Re: Docket No. 50-275-OL  
Docket No. 50-323-OL  
Diablo Canyon Units 1 and 2

ANSWER TO THE NRC STAFF QUESTIONS ON THE WESTINGHOUSE EVALUATION  
OF THE EFFECT OF GRID DEFORMATION ON ECCS PERFORMANCE

Figure 1: ROD SPACING RESULTING FROM POSTULATED GRID DISTORTION

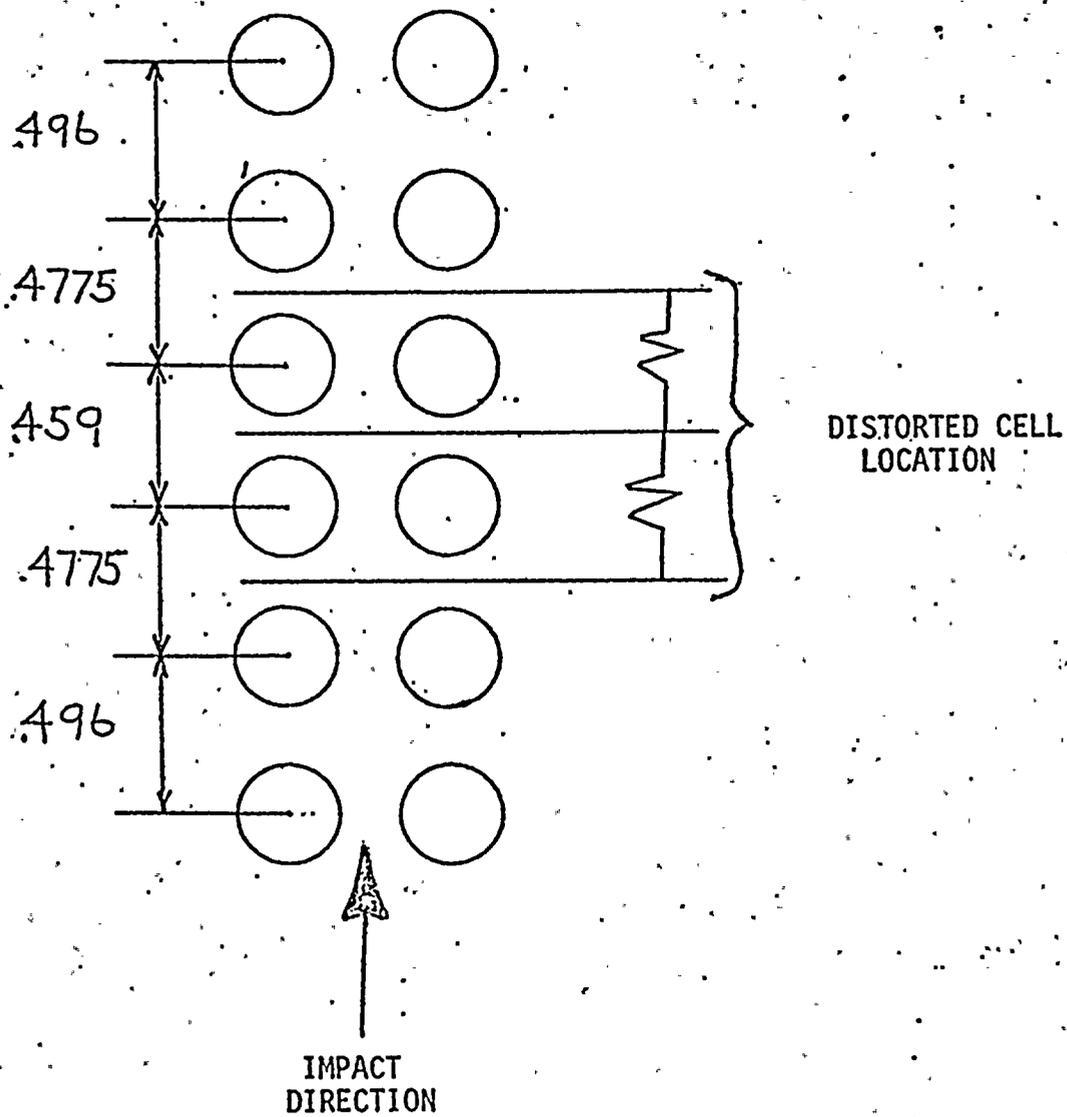
1. The blockage effect due to deformed grids may be concentrated in one or two rows of rods. Analysis of flow conditions for these rods with bundle average blockage is non-conservative. Provide analyses assuming that the maximum blockage applies to the entire bundle.
2. Provide the basis for assuming that FLECHT data from typical bundles is applicable to deformed bundles.

For conservatism, the same two rows of cells will be assumed to deform in axially adjacent grids; in this way a confined channel of set geometry is postulated to exist in the distorted assembly over a significant length. Additional conservatism is introduced into the calculation by assuming that adjacent cell rows deform within a grid. The rod-to-rod spacing in the impact direction resulting from these assumptions is presented in Figure 1 for the Diablo Canyon multi-impact case; rod pitches in the other direction are unchanged. Flow conditions about a rod in a distorted cell will be analyzed and heat transfer effects will be evaluated.

An analytical approach will be adopted to evaluate the flow heat transfer to an individual rod in the distorted assembly. The zero shear planes between adjacent rods define the flow field and may be used to assign each rod its appropriate flow passage. With this definition, the equivalent diameter for flow about a rod in the most confined channel is as follows, using Figure 1 dimensions:
